AGENDA
CITY OF CREVE COEUR
PLANNING AND ZONING
300 NORTH NEW BALLAS RD
FEBRUARY 6, 2023
6:00 PM

- 1. PUBLIC HEARING Application #22-031: A Conditional Use Permit with Associated Site Development Plan for A New Chick Fil A Restaurant with Drive Through Services Located at 12398 Olive Boulevard**

APPLICATION TO PLANNING AND ZONING COMMISSION #22-031: A CONDITIONAL USE PERMIT WITH ASSOCIATED SITE DEVELOPMENT PLAN FOR A NEW CHICK FIL A RESTAURANT WITH DRIVE THROUGH SERVICES LOCATED AT 12398 OLIVE BOULEVARD

Figure 6
Site Generated Traffic Volumes

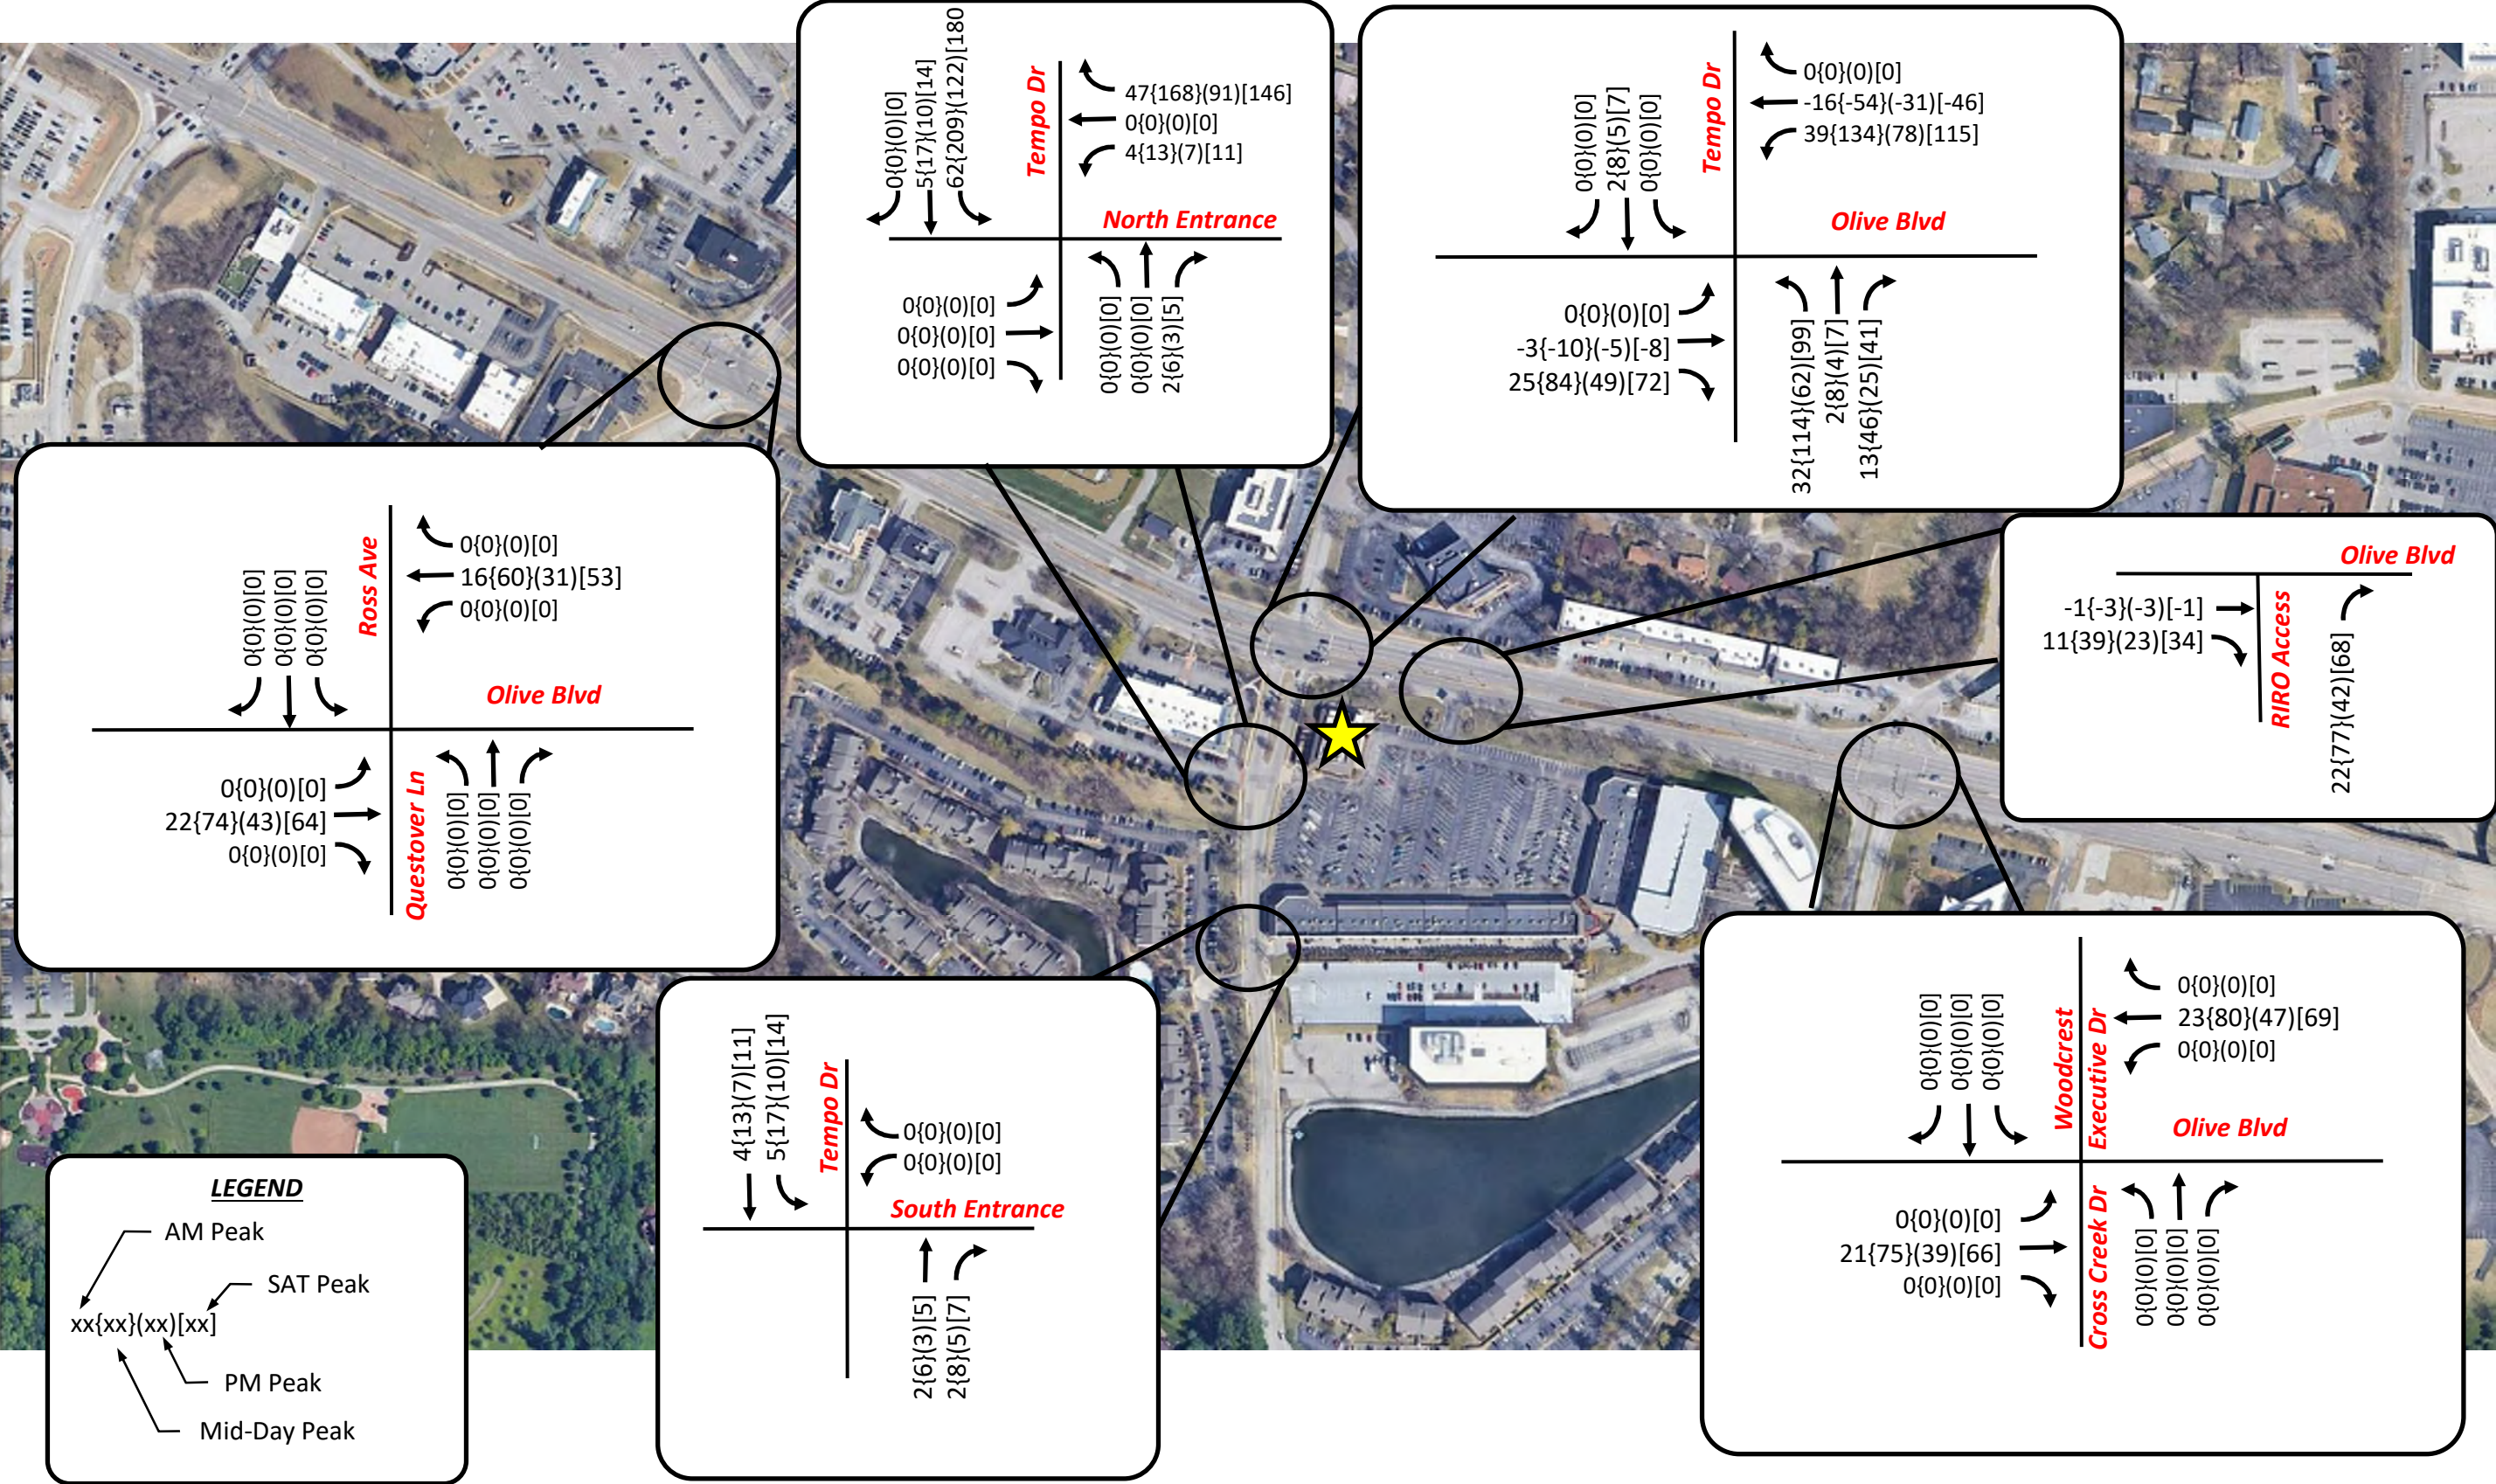
The site generated trips are shown in **Figure 6** of the report. The site generated trips do not add up in **Figure 6**. For example, at the intersection of Olive Boulevard and Tempo Drive there are 22 vehicles making an eastbound right-turn, 30 vehicles making a westbound left-turn, and 7 vehicles making a southbound through. This should equal 59 vehicles heading southbound at Tempo Drive and the North

Entrance; however, 66 vehicles are shown in **Figure 6**. It is recommended that this figure be revisited when applying the new directional distribution.

8. The site generated trips shown in **Figure 6** do not add up correctly based on the site generated trips provided in **Table 3** and the directional distribution shown in **Figure 5**.

9. The site generated trips shown in **Figure 6** do not add up correctly based on the site generated trips provided in **Table 3** and the directional distribution shown in **Figure 5**.

18. It is recommended that **Figure 6** be revisited and corrected when applying the new directional distribution.
19. It is recommended that the text on page 17 be revised to read 2045 rather than 2026.

4. It is recommended that **Figure 6** be revisited and corrected when applying the new directional distribution.
RESPONSE: Figure 6 has been updated.
5. It is recommended that the text on page 17 be revised to read 2045 rather than 2026.

9. The site generated trips shown in **Figure 6** do not add up correctly based on the site generated trips provided in **Table 3** and the directional distribution shown in **Figure 5**. **This item has been corrected in the revised documentation.**

18. It is recommended that **Figure 6** be revisited and corrected when applying the new directional distribution.
Figure 6 has been revised accordingly.
